MEMORANDUM

Project No.: 110207-007-04

Re: **RI/FS Work Plan Addendum: Log Pond Area Additional Investigation**
Kimberly-Clark Worldwide Site Upland Area RI/FS, Everett, Washington

Figure A-1 - Proposed Subsurface Explorations Overlain on Geophysical Results

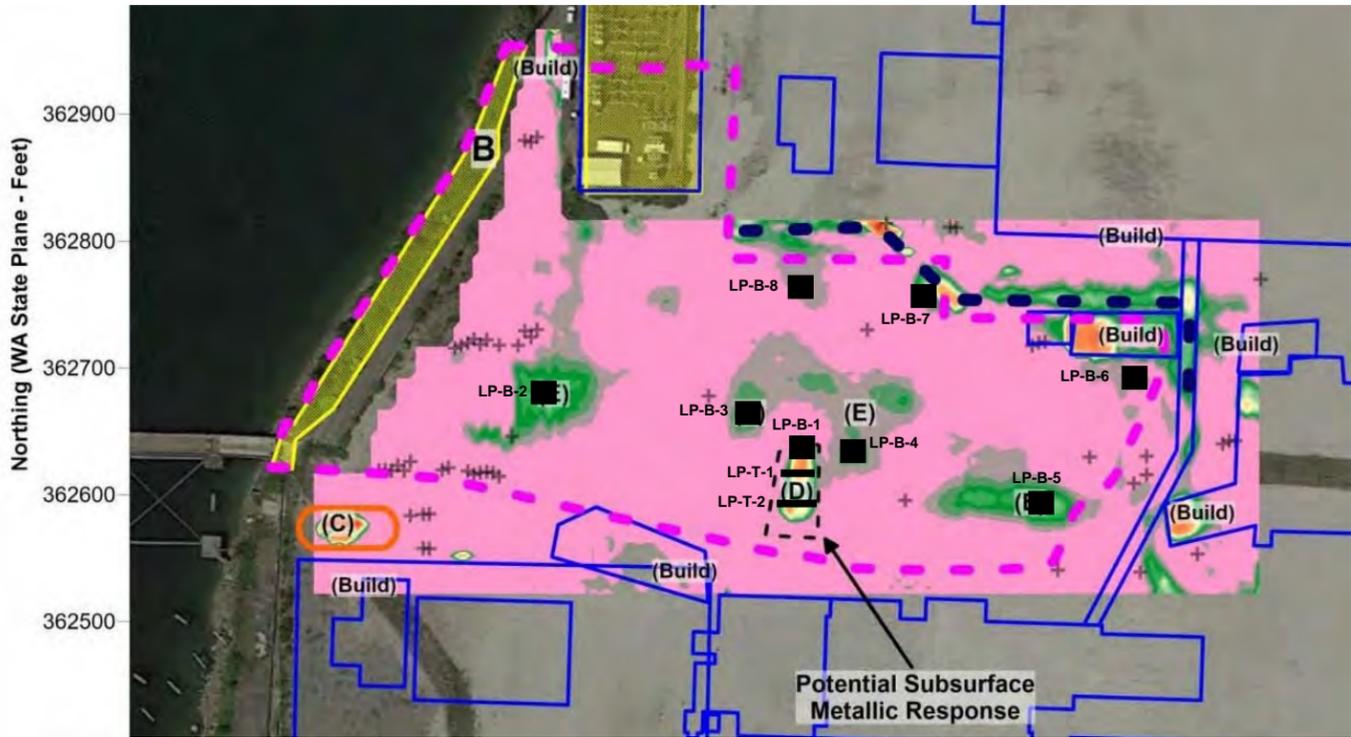
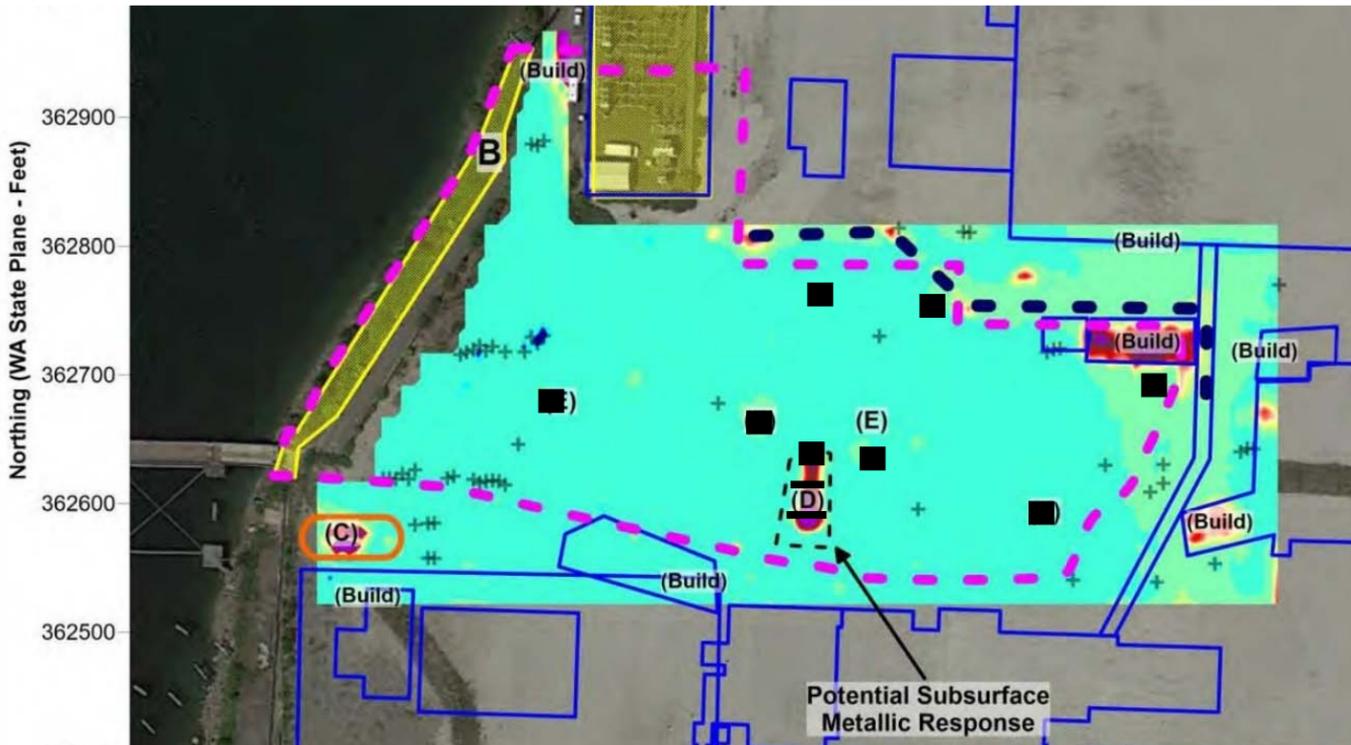
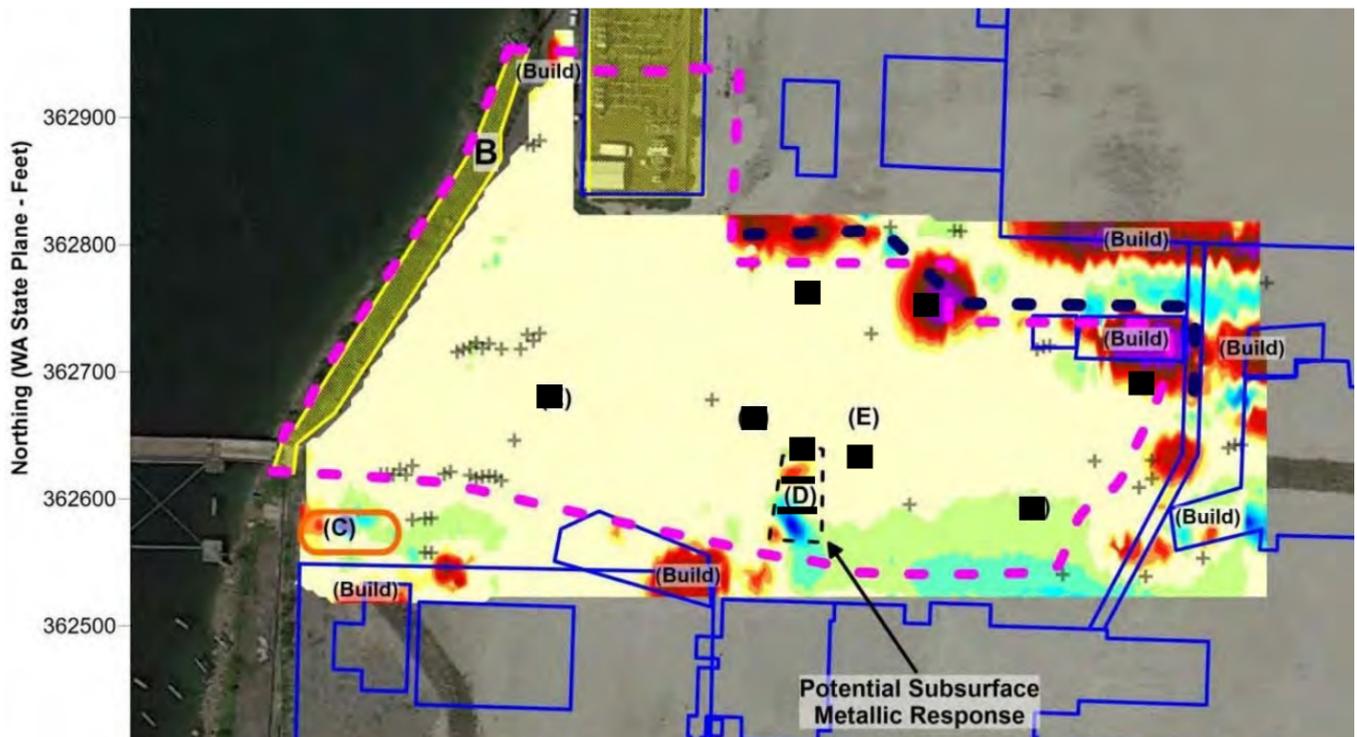
In summary, HGI (2017) identified one primary geophysical anomaly within the footprint of the former log pond. This geophysical anomaly, identified in the HGI report as Anomaly (D), is in the south-central portion of the former log pond. The combined geophysical signature of this anomaly, based on electromagnetic (EM) and magnetometer data (Figure A-1), suggests that it contains ferrous iron and is likely located within the upper 10 to 15 feet. This anomaly appears to have the same length, width, and location as the former chip reclaim conveyor, and may represent the foundation for the conveyor. It is also the area where log pond filling started, from the south to north, which is shown in attached Photograph 1 taken in 1979. A historical design drawing of the chip reclaim conveyor foundation indicates that it was 66 feet long, and its metal-containing concrete foundation, which, if still present, would produce the geophysical response indicated in the survey results. However, the strong metallic response and dipolar magnetic anomaly could also indicate multiple metallic objects. Therefore, this anomaly warrants further investigation as described below.

Outside of Anomaly D, the geophysical survey did not identify significant variability in electrical conductivity of the log pond fill material. Slight shallow subsurface conductivity variations are identified in the HGI report as anomalies (E) (labeled on Figure A-1). These areas have only slightly higher conductivity values than the background values observed across the rest of the former log pond area and do not have corresponding electromagnetic in-phase or metallic responses. According to HGI (2017), these combined results indicate that the response is likely due to small variation in soil type or slightly higher moisture content of soils very near to the surface. Nevertheless, these anomalies warrant further investigation to confirm subsurface conditions as described below.

Two shallow trenches (LP-T-1 and LP-T-2; Figure A-1) will be excavated perpendicular to the length of anomaly D to confirm the presence or absence of the former chip reclaim conveyor

In addition, eight borings will be advanced by roto sonic methods through the fill material to the top of the native soil to both investigate geophysical anomalies and evaluate the nature and thickness of fill material. The proposed borings are as follows (Figure A-1):

- LP-B-1 will be completed on the northern edge of Anomaly D irrespective of presence or absence of the conveyor foundation encountered during trenching.
- LP-B-2, LP-B-3, LP-B-4, and LP-B-5 will be completed where the greatest electrical conductivity contrasts are identified within HGI anomaly areas (E), indicating the highest potential for non-soil materials.
- LP-B-6 will be completed within a conductivity anomaly area in the northeast corner of the log pond.
- LP-B-7 will be completed within the geophysical anomaly (conductivity and magnetic) located adjacent to the log pond bulkhead on the northern edge of the log pond.
- LP-B-8 will be completed within a conductivity anomaly along the north edge of the log pond.
